Safety Bulletin

No: SB072 Rev: 0 Date: December 20, 2012

Modification Required to T-bar for Dual Pin Torque Track

Figure 3: Illustration showing retainer plate size and placement

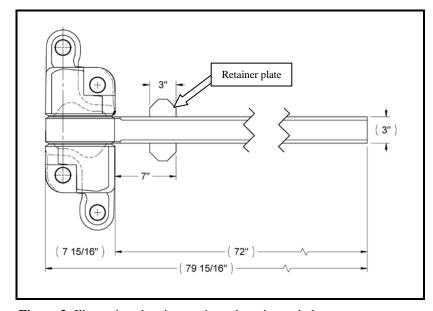
TESCO personnel have identified a potential safety hazard regarding the upper T-bar for the dual pin torque track system. This T-bar has been used in some ESI Top Drive installations. The upper T-bar is secured with a bolted clamp plate partially shown in the pictures in Figure 1. In the pictured installation, the torque track has a 10-inch offset from the edge of the clamp plate. If the clamp plate bolts are not torqued according to spec and/or come loose during top drive operation, the upper T-bar could slide out of position. If the torque track shifts toward the clamp plate, the clearance for the torque bushing to pass would be lost. In this state, if the top drive is raised or lowered past the T-bar, a collision between the torque bushing and the clamp would occur. This may damage the torque arrest beam, clamp and the torque bushing, with a potential for dropped objects.

The potential for collision if the T-bar clamp became loose is eliminated with the addition of a retainer plate to the T-bar shaft. The retainer plate prevents the T-bar from sliding all the way into the clamp, ensuring that sufficient clearance is available for the torque bushing to pass. Figure 2 shows the T-bar with the retainer plate added. The retainer plate will be added to all new T-bars to eliminate such a hazard. Figure 3 shows the retainer plate size and placement. For a more detailed view, refer to drawing number 5007241-1.

T-bars in existing field installations should be modified by a qualified TESCO technician or customer field personnel to add the retainer plate as soon as practical. Until the modification is made, equipment operators should be made aware of the potential that the upper T-bar could slide out of position and its possible effects on the top drive, and monitor their operations accordingly.
